**IPCC WGII
Fourth Assessment Report
Climate Change Impacts, Adaptation and Vulnerability**

Government Review of Final Draft

REVIEW COMMENTS

Summary for Policymakers

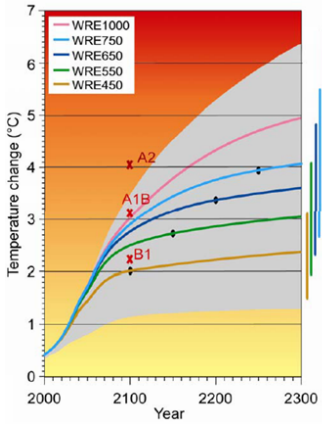
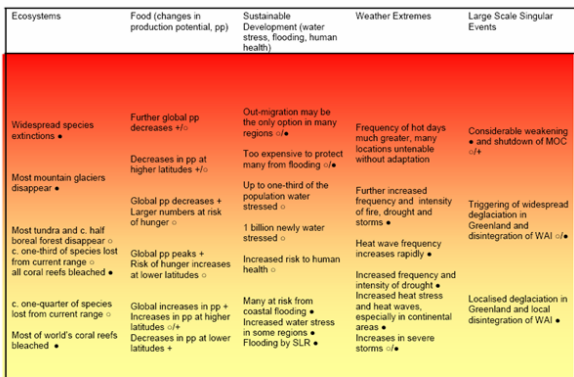
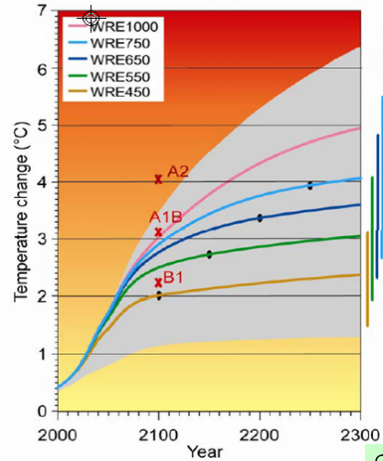
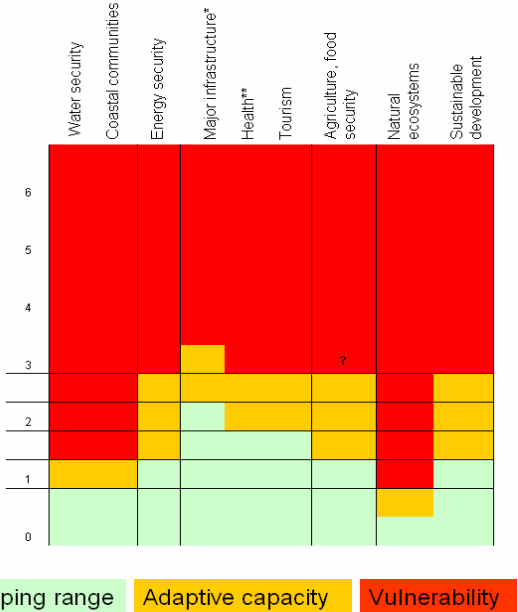
892	11	0			TABLE SPM-1: Despite all the very valuable information this table contains, it is simply ineffective as a communication tool. Our concern is that too much information is being put into one Table and as a result the main message is lost. In particular, the top panel is confusing and provides too much information. We suggest that the top panel should be replaced with Figure SPM-7 from the AR4 WG1 report. This would allow the Table to be reconfigured to emphasize the key vulnerability information. In addition, the SLR information is too small and easily lost. Specific concerns with the top panel are: a)The reader is referred back to the TAR in order to get info about the WRE scenarios - this is not sufficient, b) There is no information provided for the reader to make a link between the WRE scenarios and the SRES scenarios, c) THREE different sets of information are provided to describe the WRE scenarios (CO2 conc, CO2 equiv. conc, and warming by 2300), and yet no detailed info is provided for SRES scenarios, d) the inclusion of 5 tick marks for each arrow is too much information for the SPM. (Govt. of Canada)

893	11	0			Table SPM-1. The arrows fpr the SRES scenarios gives the impression that they are presented on a timeline based on the upper row (2020, 2050, 2080). It might be a help to pronounce those tick marks on the lines spanning the temperture respons for the various SRES scenarios (cf. page 12, line 43 and 45). In some cases, not all of the tick marks are visible (overlapping?) (Govt. of Sweden)
894	11	0			All page 11 and tables SPM -1 and SPM-2 (page12) are illegible and not easily exploitable by and for the decision makers. It would be desirable to replace them by one synthesis or to remove them. (Govt. of Mali)
895	11	1	10	39	This section is patchy and lacks a consistent approach to timing and scale. The reader is left with the impression that these are the only impacts in a region which is surely not true. It would be helpful if for consistency each regional section could include at least one food and one water-related quantitative example. We have provided some suggestions below for Africa and Asia but the same criterion should be applied to all regions. The presentation of the section could be improved by introducing some graphics summarising the impacts for each region, for example Figure 9.5 on Africa, Figure 10.4 on Asia and Figure 12.3 on Europe. This would help also to show the spatial distribution of impacts in the same region. (Govt. of UK)

896	11	1	11	55	Table SPM-1: To be consistent with Table SPM-2 in the adopted WG1 SPM, one should label the sea level rise numbers with "excluding future rapid dynamical changes in ice flow", as this potentially significant contribution is left out form these projections.
